TECHNICAL MEMORANDUM

To: Jeff Rice, PE, El Paso County

From: Mike Bramlett, PE, JR Engineering, Engineer of Record

Subject: Sand Creek Channel Resubmittal – Design Support Memo

JR Cross Section 12070 – CCES Cross Section 20+83.66

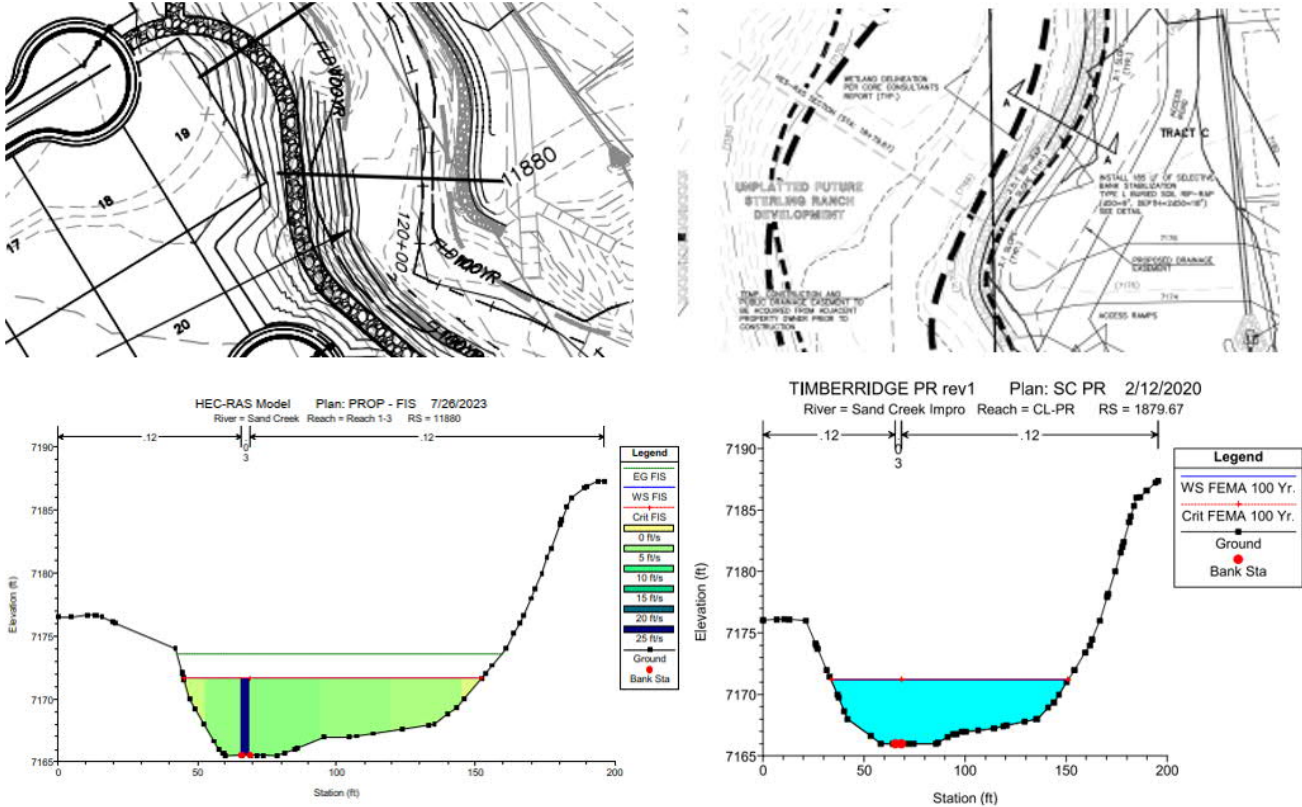
This cross section is below the grade control structure placed at the end of the POCO road culvert improvements and it is evident the cross sections are slightly different between the two models leading to the larger than anticipated variation in results.

JR Cross Section 11569 – CCES Cross Section 15+07.91

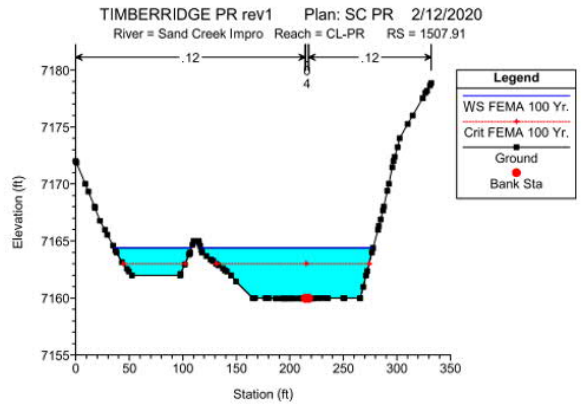
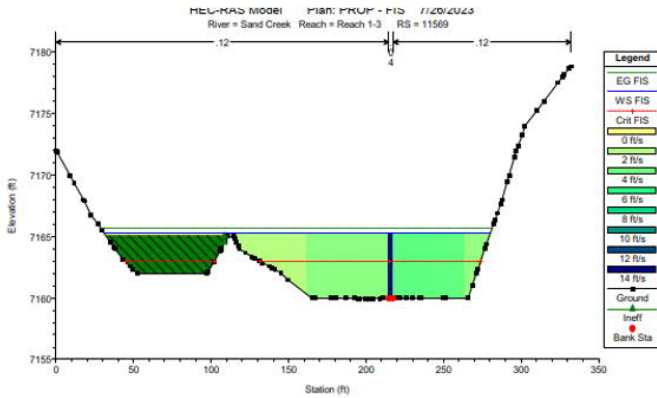
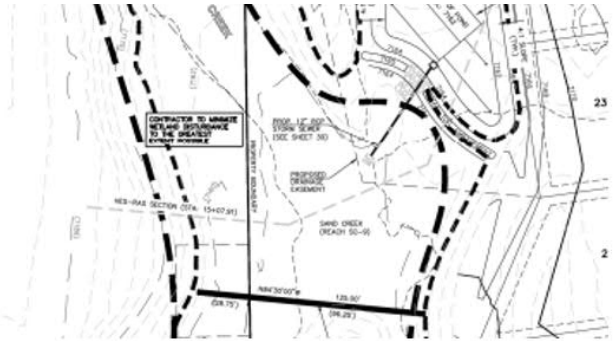
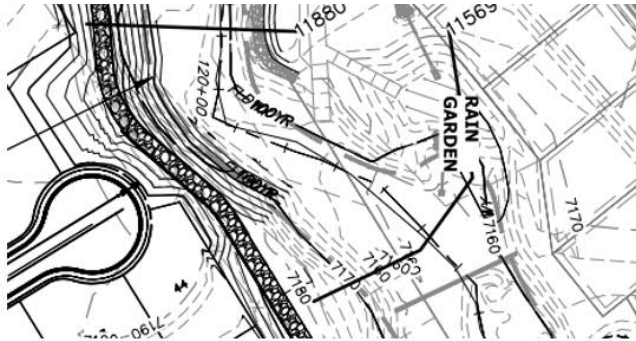
This cross section is just above grade control structure 2 and JR's model shows ineffective flow area while CCES model does not which lead to higher WSEL in the JR model and minor variations in results.

JR Cross Section 11368 – CCES Cross Section 11+45.05

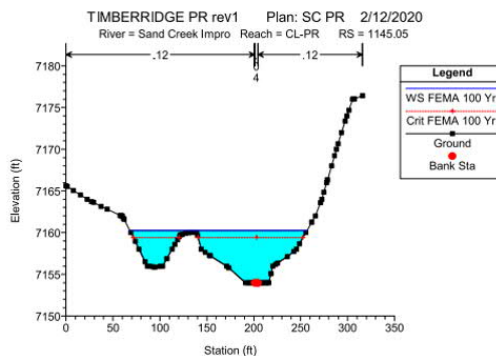
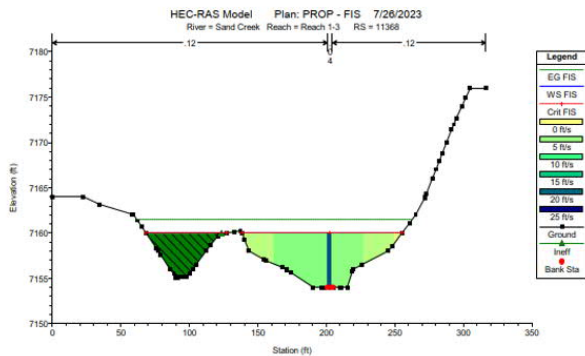
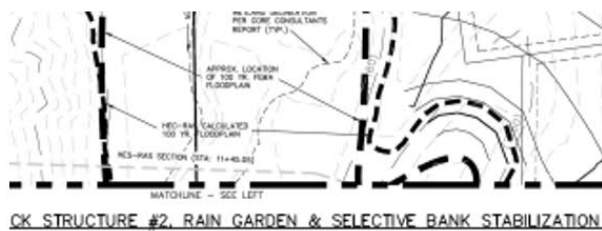
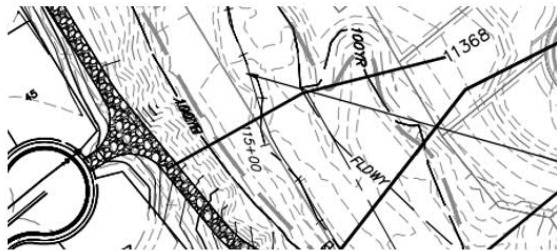
This cross section is below grade control structure 2 and JR's model shows ineffective flow area while CCES model does not which lead to a much smaller Flow Area in the JR model and larger than anticipated variations in results.

JR Cross Section 11103 – CCES Cross Section 9+02.80

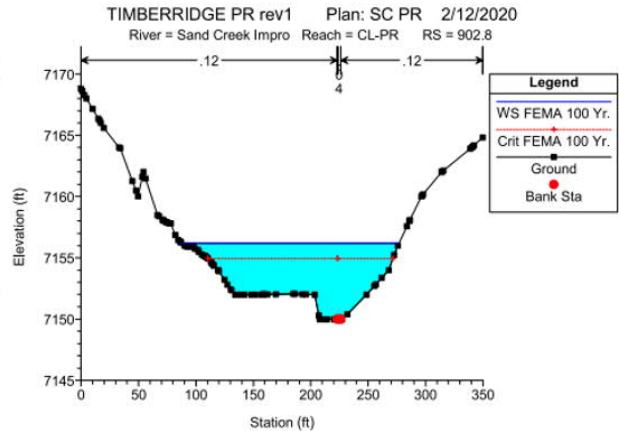
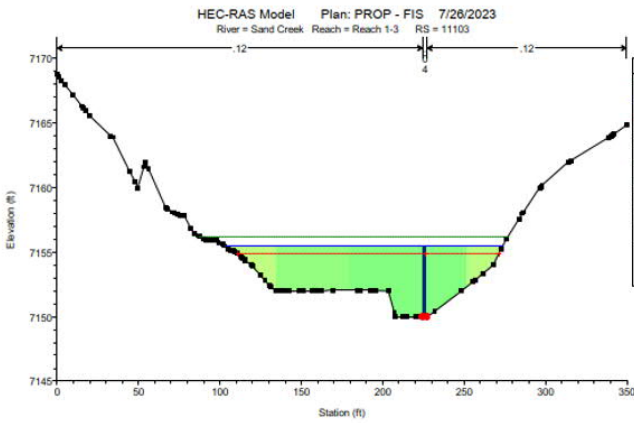
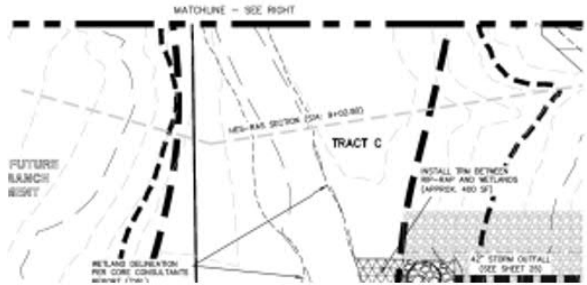
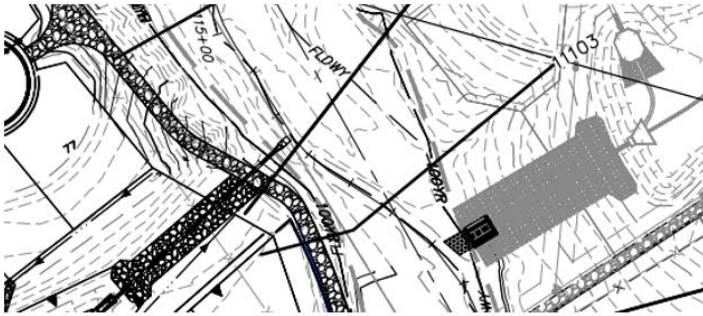
This cross section is below grade control structure 2 and while the cross sections appear similar, the WSEL and Flow area different between the models, causing a variation in results.

JR Cross Section 10925 – CCES Cross Section 5+20.20

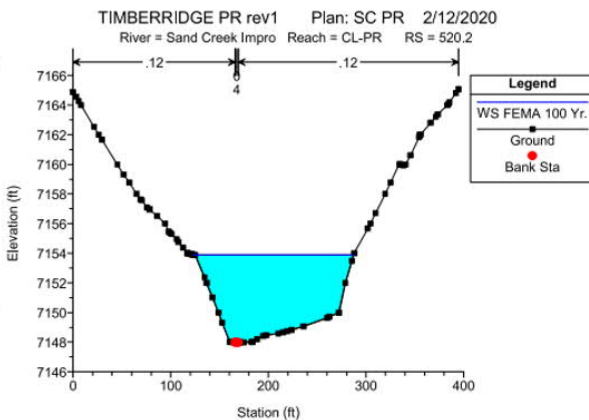
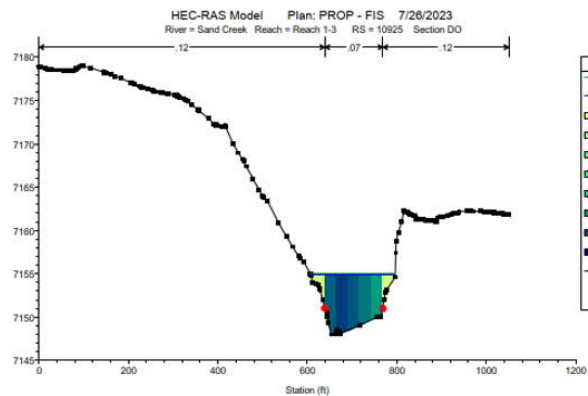
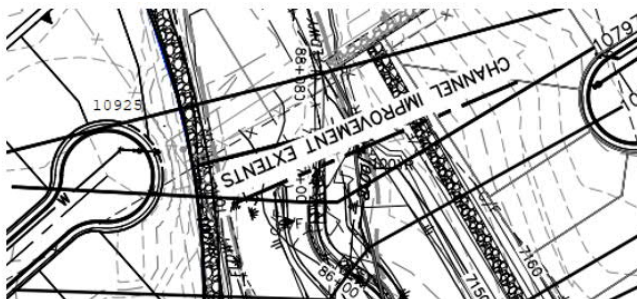
This cross section is above grade control structure 1 improvements and it is evident the cross sections are slightly different between the two models leading to the larger than anticipated variation in results.
